SUBJECT: Requests NRC review & approval of change to PVNGS grid stability analyses due to construction of new high voltage transmission line over two of five transmission lines which serve station.

**Subject: Palo Verde Nuclear Generating Station (PVNGS)  
Units 1, 2, and 3  
Docket Nos. STN 50-528/529/530  
Request for NRC Review of Revised Grid Stability Analyses**

**CHANGES TO THE PVNGS  
GRID STABILITY STUDIES**

**REVISED GRID STABILITY ANALYSIS (UFSAR  
SECTION 8B) AND REVISED UFSAR PAGES**

GRID SYSTEM  
 (SHEET 1 OF 2)  
 Figure 8.1-1

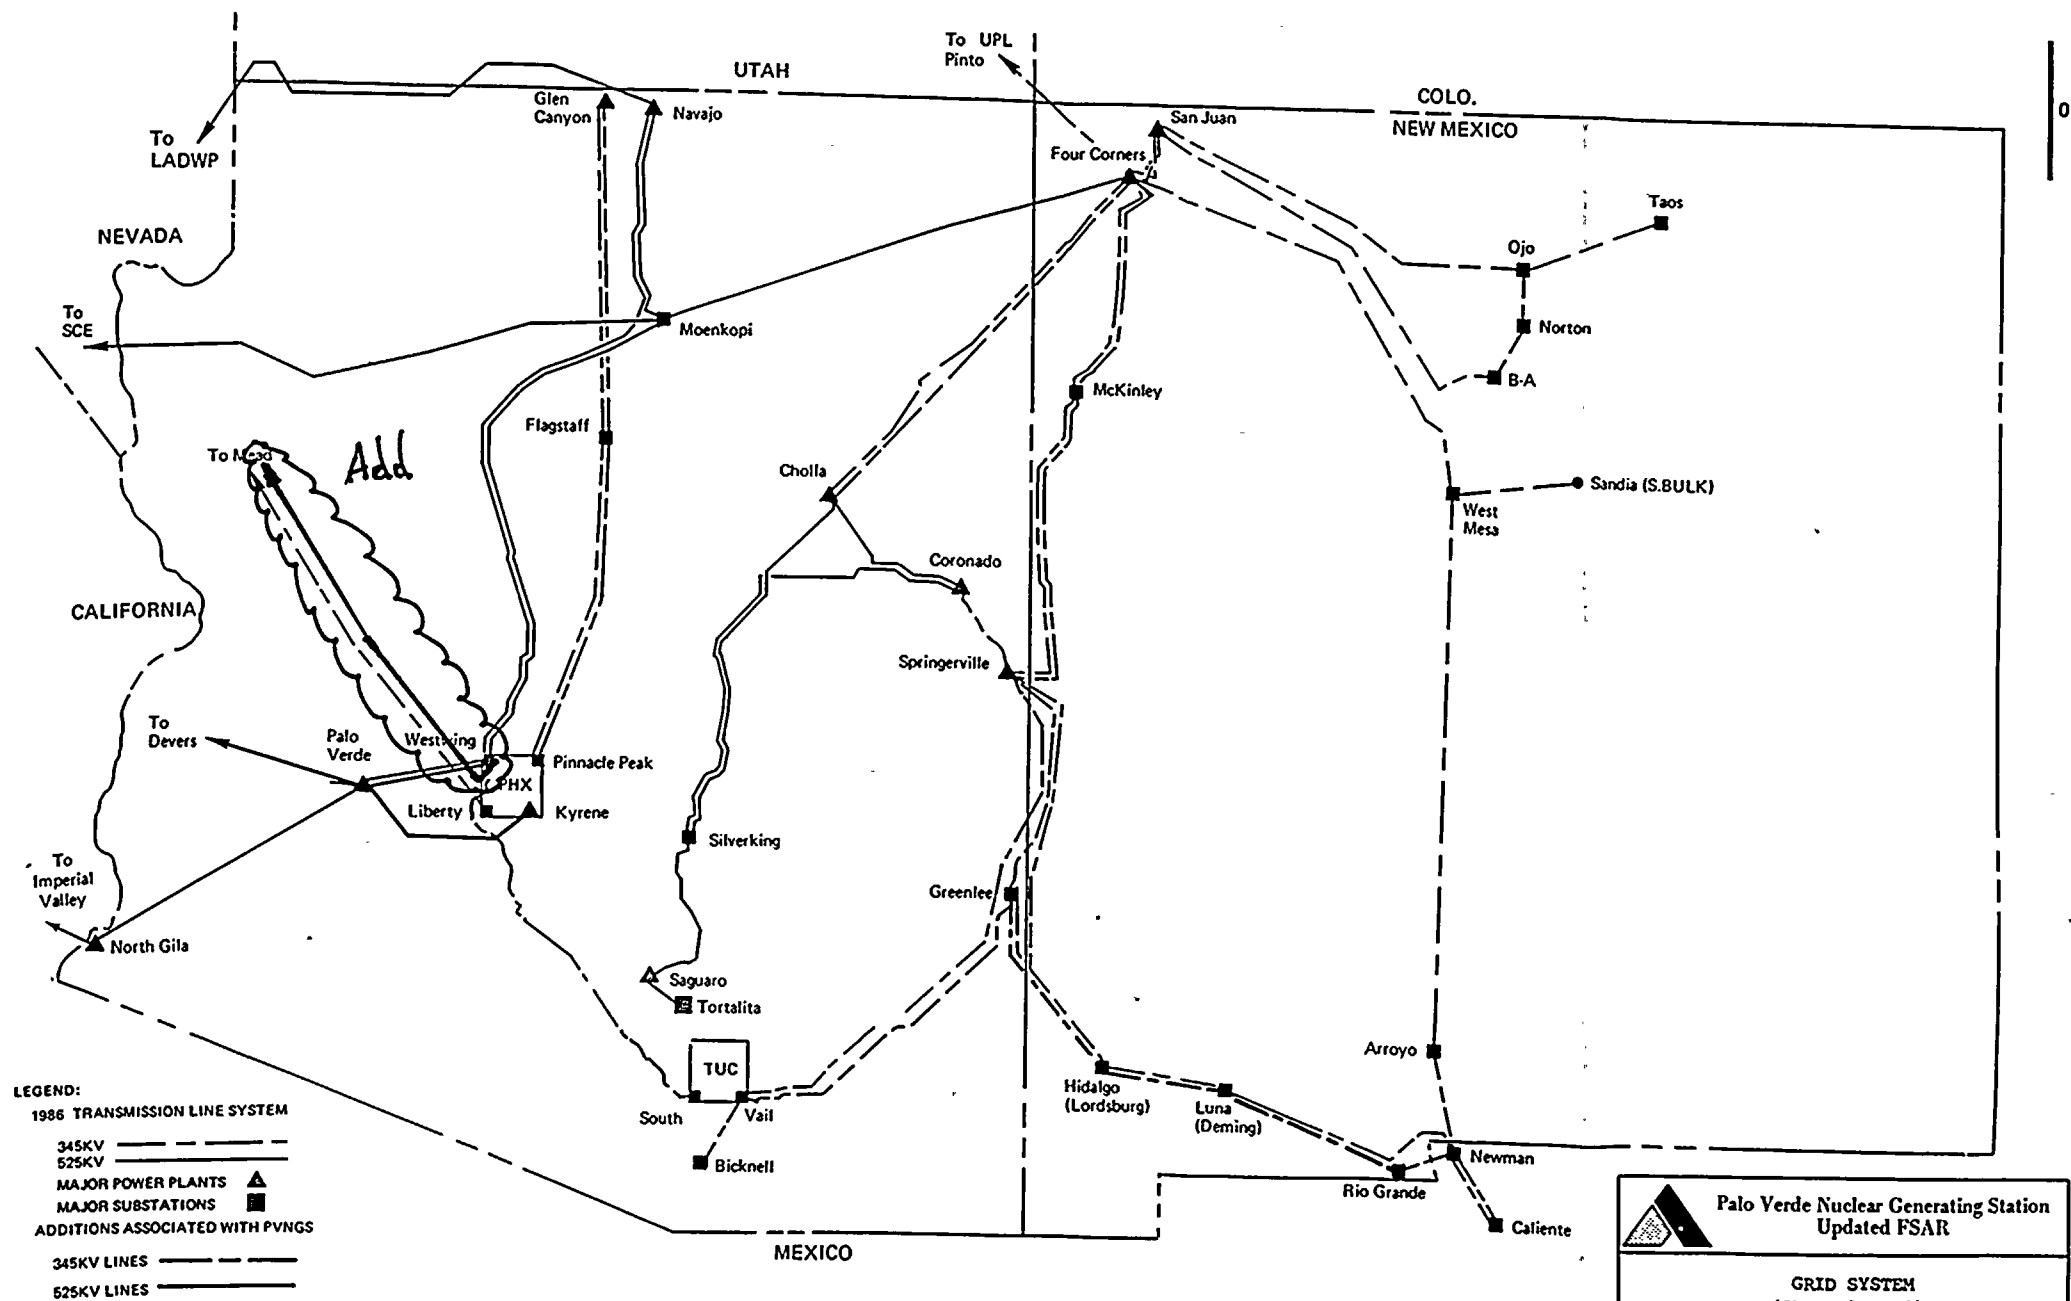
Recently, the Salt River Project installed a 525 kV transmission line between their Mead and Perkins substations. This new line crosses over two of the five transmissions lines that serve the Palo Verde Nuclear Generating Station (PVNGS); i.e., the Westwing I and Westwing II lines. Due to the installation of this new Salt River Project transmission line, an unreviewed safety question (USQ) was introduced in that a malfunction of a different type was created and an increase in the probability of a malfunction of equipment important to safety exists.

Figure 8.1-1
